Exhibit A

Recommended Amendments to the 2018 International Building Code City of Amarillo, Texas

FIGURE 1511.3.1.1 HAIL EXPOSURE MAP

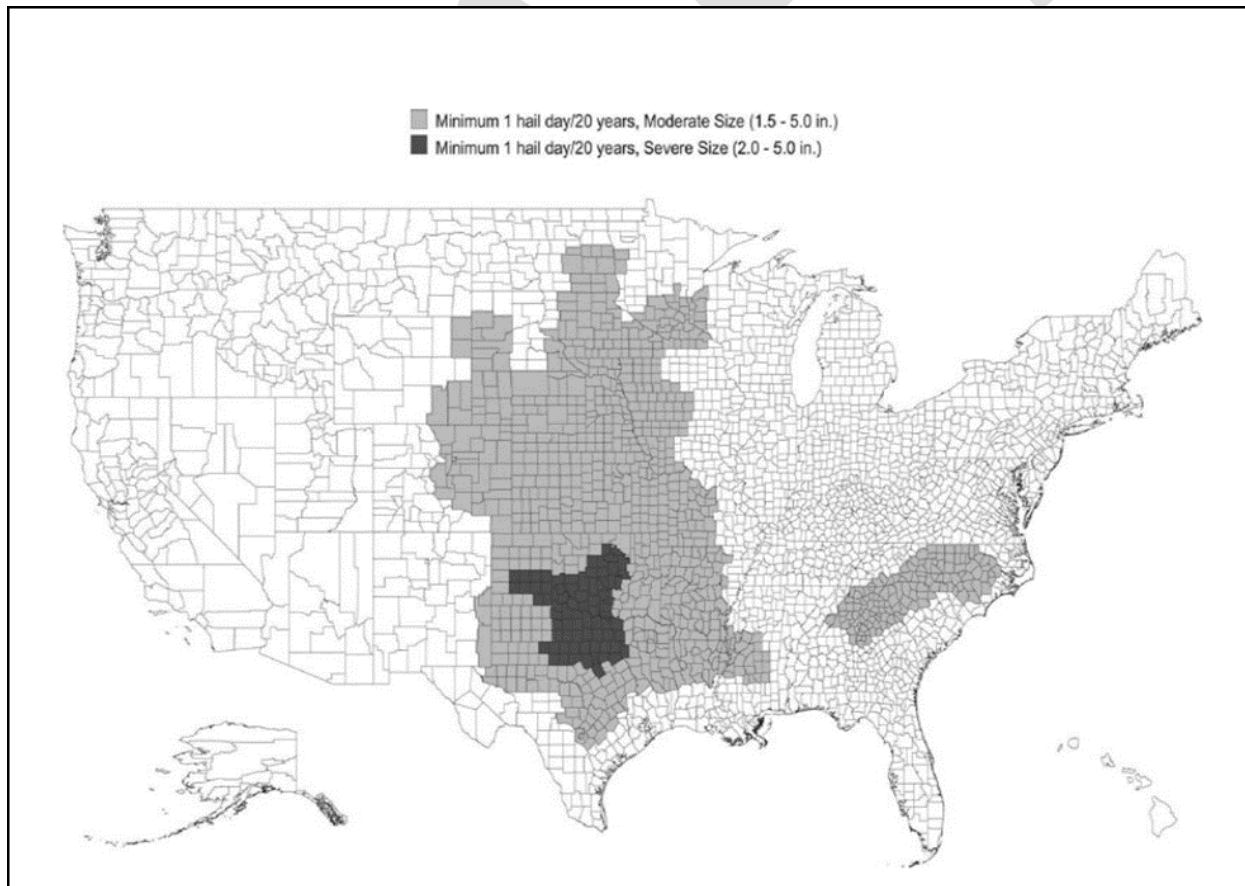
****Section 1511.3.1.1; insert Figure 1511.3.1.1; change to read as follows:**

1. Where the existing roof or roof covering is water-soaked or has deteriorated to the point that the existing roof or roof covering is not adequate as a base for additional roofing.
2. Where the existing roof covering is wood shake, slate, clay, cement or asbestos-cement tile.
3. Where the existing roof has two or more applications of any type of roof covering.
4. For asphalt shingles, when the building is located in an area subject to moderate or severe hail exposure according to Figure 1511.3.1.1.

(Reason: Due to the of weather in the Panhandle, wind and hail damage is more prone when asphalt shingles used for re-covering; contractors unable to verify if any of the decking may need to be replaced and unable to verify the flashing integrity)

*****Figure R602.6.1; delete the figure and insert the following figure:**

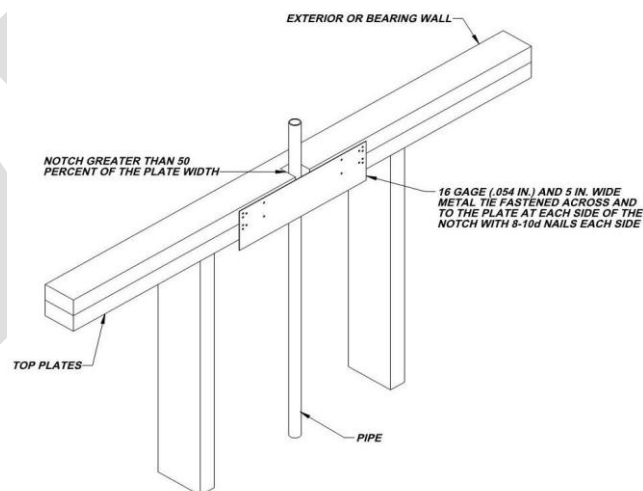
R602.6.1 Drilling and notching of top plate. When piping or ductwork is placed in or partly in an exterior wall or interior load-bearing wall, necessitating cutting, drilling or notching of the top plate by more than 50 percent of its width, a galvanized metal tie not less than 0.054 inch thick (1.37 mm) (16 Ga) and 4 ½ inches (38 mm) 5 inches (127 mm) wide shall be fastened across and to the plate at each side of the opening with not less than eight 10d (0.148 inch diameter) having a minimum length of 1 ½ inches (38 mm) at each side or equivalent. Fasteners will be offset to prevent splitting of the top plate material. The metal tie must extend a minimum of 6 inches past the opening. See figure R602.6.1. *{Remainder unchanged}*

(Reason: Amendment to provide additional assurance of maintaining the integrity of the framing by spreading the nailing pattern.)

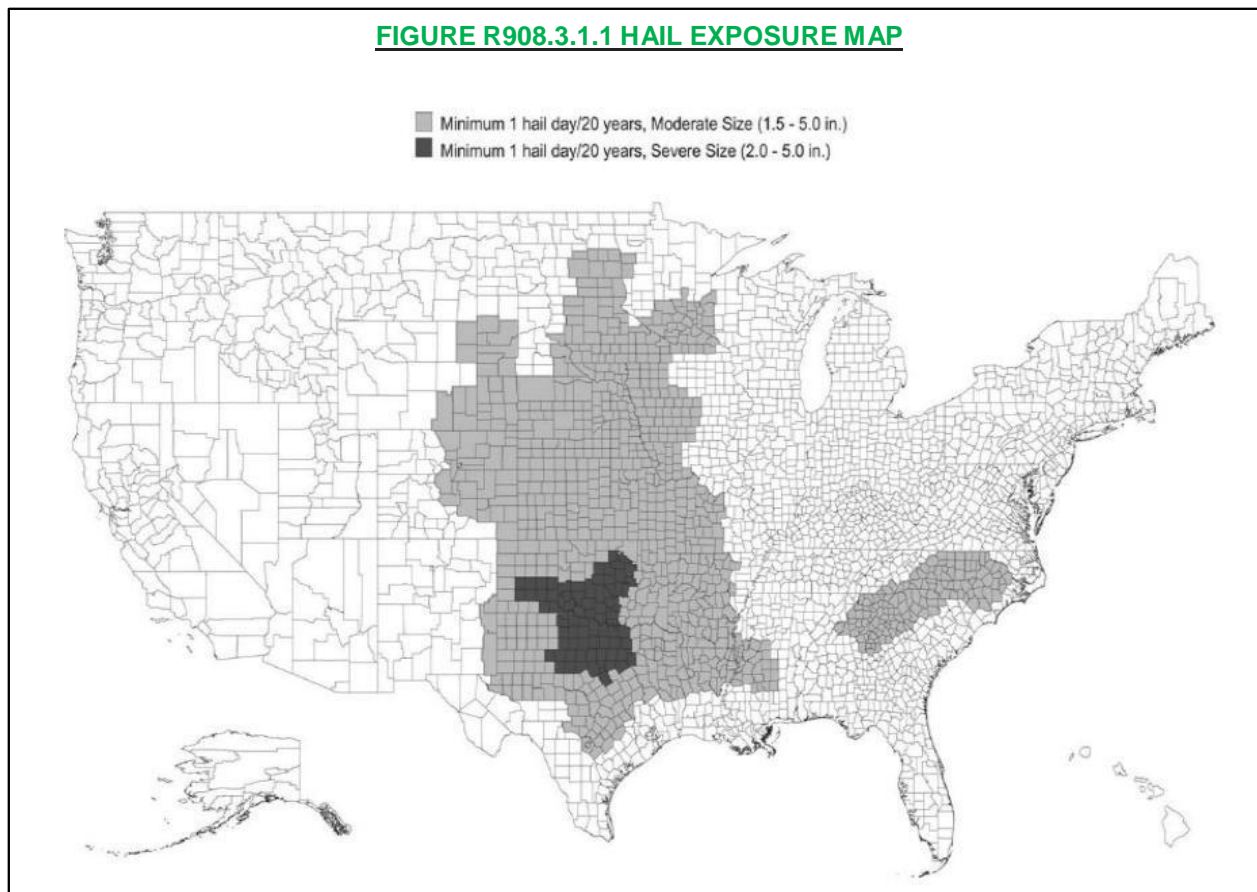
****Section R908.3.1.1; insert Figure 908.3.1.1; change to read as follows:**

1. Where the existing roof or roof covering is water-soaked or has deteriorated to the point that the existing roof or roof covering is not adequate as a base for additional roofing.
2. Where the existing roof covering is wood, slate, clay, cement or asbestos-cement tile.
3. Where the existing roof has two or more applications of any type of roof covering.
4. For asphalt shingles, when the building is located in an area subject to moderate or severe hail exposure according to Figure R908.3.1.1.

(Reason: Due to the of weather in the Panhandle, wind and hail damage is more prone when asphalt shingles used for re-covering; contractors unable to verify if any of the decking may need to be replaced and unable to verify the flashing integrity; roof framing practices in the Panhandle have typically utilized 2 x 6 framing members, not designed for the additional weight of a second layer of shingles.)
